New 6" AdvanceDrive Wheels

OPERATORS: SlideDriver™ operator models using 6" AdvanceDrive wheels

DATE: 09/01/2020

SUBJECT: New 6" aluminum AdvanceDrive wheels

Figures 1 and 2 (below) show the differences between old and new AdvancedDrive wheel assemblies.

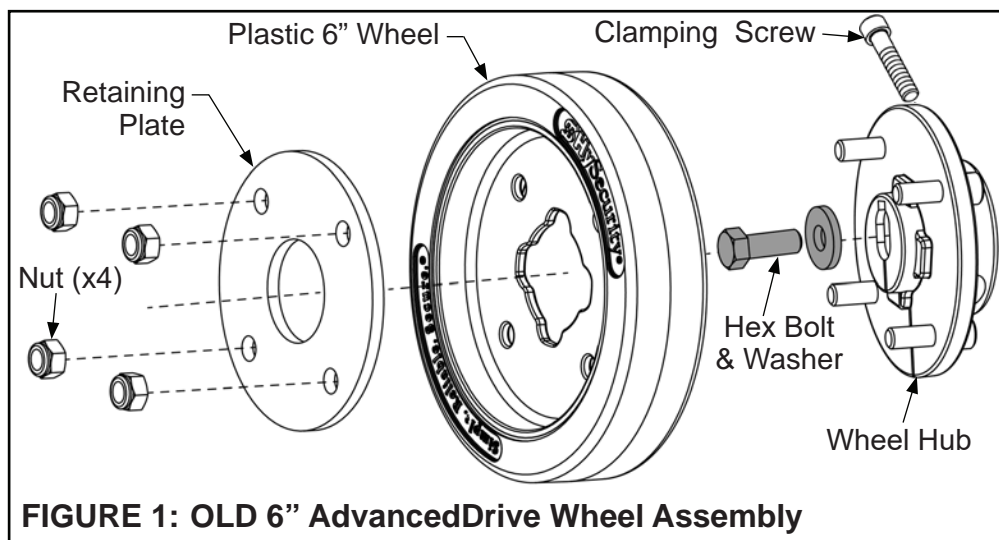
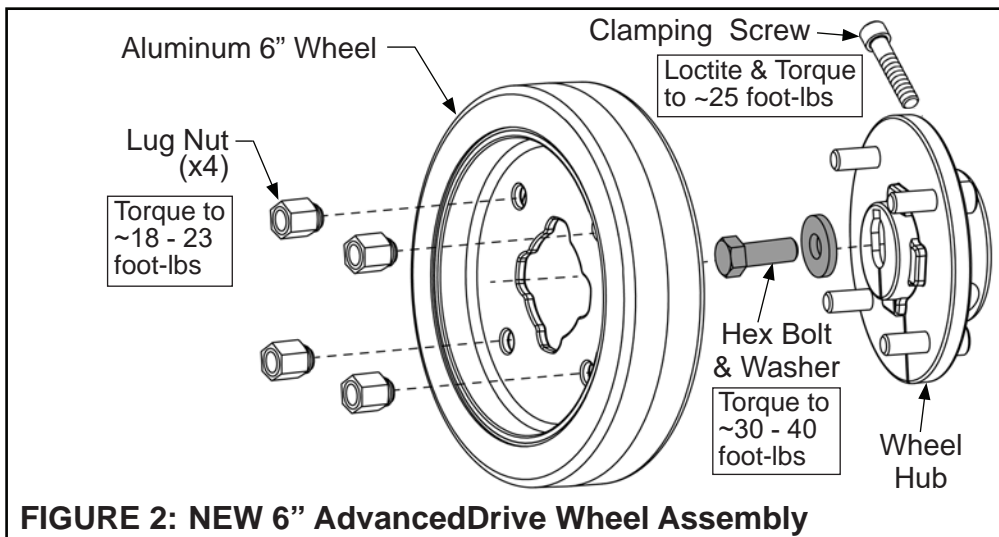
The 6" AdvanceDrive wheels used in SlideDriver models have been replaced with new wheels that do not require a metal retaining plate. The 8" AdvancedDrive and 8" XtremeDrive wheels used in some models will be updated similarly at a later date.

Simpler disassembly during maintenance.

NOTE: New wheels are compatible with the hubs from plastic wheels but require new nuts. If replacing older aluminum wheels they will need a kit with a new hub.
